**[Docket No. FAA-2020-0442; Project Identifier AD-2020-00260-E; Amendment 39-21640; AD 2021-14-13]**

#### **Airworthiness Directives; Pratt & Whitney Turbofan Engines**

**ACTION:** Final rule.

**Figure 1 to Paragraph (g)(1)(iii) – Crack Inspection Critical Areas**

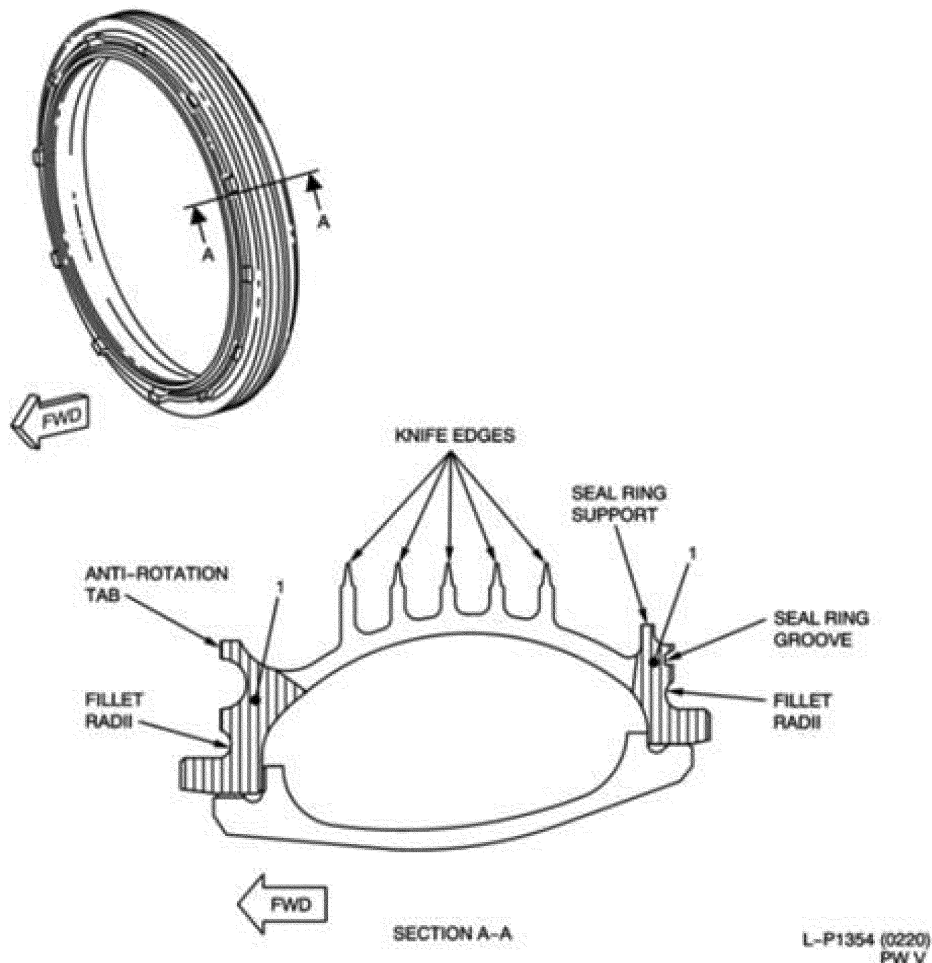
MTU requested clarification regarding whether the mating HPT 1st-stage disk or HPT 2nd-stage hub needs to be replaced if a crack is found after performing the inspections proposed by paragraph (g)(2)(iii) of the NPRM (paragraph (g)(1)(iii) of this AD), or if both the mating HPT 1st-stage disk and HPT 2nd-stage hub need to be replaced.

Delta and MTU requested that the FAA clarify the location of the forward and aft edges of the HPT 2nd-stage air seal assembly. Delta asked if the forward edge is the barrel section forward of the #1 knife-edge or any part that extends beyond the barrel section.

Delta and FedEx requested that the FAA clarify the definition of “through-crack.” Delta asked if a “through-crack” is a crack going through the axial direction or radial direction of the HPT 2nd-stage air seal assembly. Delta referenced Figure 5 of NDIP-1217 that appears to show a through-crack in the axial direction. Delta inferred from paragraph (i)(4) of the NPRM that a through-crack is in the radial direction. Delta requested a diagram to help illustrate what constitutes a through-crack.

FedEx stated that a lenticular seal is a two-piece component that becomes an inseparable assembly during manufacturing. As a result, it would be impossible to distinguish a through-crack from a surface crack over a large area of the HPT 2nd-stage air seal assembly's exterior since its interior surfaces are inaccessible. FedEx cited Chapter 72-52-60, Inspection/Check-01, Figures 801 and 801A, of the PW2000 Series Engine Manual, which highlights areas where through-thickness cracks are critical. According to FedEx, however, these images fail to address the ability to determine whether a surface crack is a “through-crack.” Additionally, the PW2000 Series Engine Manual does not provide dimensions that bound the areas making HPT disk replacement subjective.

The FAA did not revise this AD in response to this comment. A crack, as identified in the shaded regions of Figure 1 to paragraph (g)(1)(iii) of this AD (Figure 1), which extends towards the knife-edge region of the HPT 2nd-stage air seal assembly, impacts the serviceability of the mating HPT 1st-stage disk and the HPT 2nd-stage hub. A crack identified in the shaded region of Figure 1 of this AD of the HPT 2nd-stage air seal assembly results in the requirement to remove the HPT 2nd-stage air seal assembly, mating HPT 1st-stage disk, and HPT 2nd-stage hub.

If a crack is found as identified in the shaded region of Figure 1 to paragraph (g)(1)(iii) of this AD (Figure 1) that extends toward the knife-edge region of the HPT 2nd-stage air seal assembly, this AD requires replacement of the HPT 2nd-stage air seal assembly, mating HPT 1st-stage disk, and HPT 2nd-stage hub.

The FAA removed references to “forward edge” and “aft edge” of the HPT 2nd-stage air seal assembly from this AD. In their place, the FAA added Figure 1 to paragraph (g)(1)(iii) of this AD to specify the locations of the HPT 2nd-stage air seal assembly that require inspection for cracks.

The FAA agrees that it is difficult to differentiate between a surface crack and through-crack; therefore, the FAA removed references to “through-crack” from this AD. The FAA notes that any crack, in any direction, found in the HPT 2nd-stage air seal assembly, requires removal of the HPT 2nd-stage air seal assembly from service. As stated in an earlier response, the FAA added Figure 1 to show the locations of the HPT 2nd-stage air seal assembly that require inspection for cracks. However, the FAA is not providing dimensions that bind the areas. If the inspections of the HPT 2nd-stage air seal assembly reveal a crack in the shaded regions of Figure 1, which extends towards the knife-edge region, the HPT 2nd-stage air seal assembly must be removed from service.

(iii) During the visual inspection or FPI required by paragraph (g)(1)(i) of this AD, if a crack is found in the shaded regions of the HPT 2nd-stage air seal assembly identified in Figure 1 to paragraph (g)(1)(iii) of this AD (Figure 1), which extends towards the knife-edge region of the HPT 2nd-stage air seal assembly, remove the HPT 2nd-stage air seal assembly, mating HPT 1st-stage disk, and HPT 2nd-stage hub from service, and replace the parts with parts eligible for installation. In order to return the mating HPT 1st-stage disk and HPT 2nd-stage hub to service, the inspections of the HPT 2nd-stage air seal assembly cannot reveal a crack identified in the shaded regions of Figure 1, which extends towards the knife-edge region.
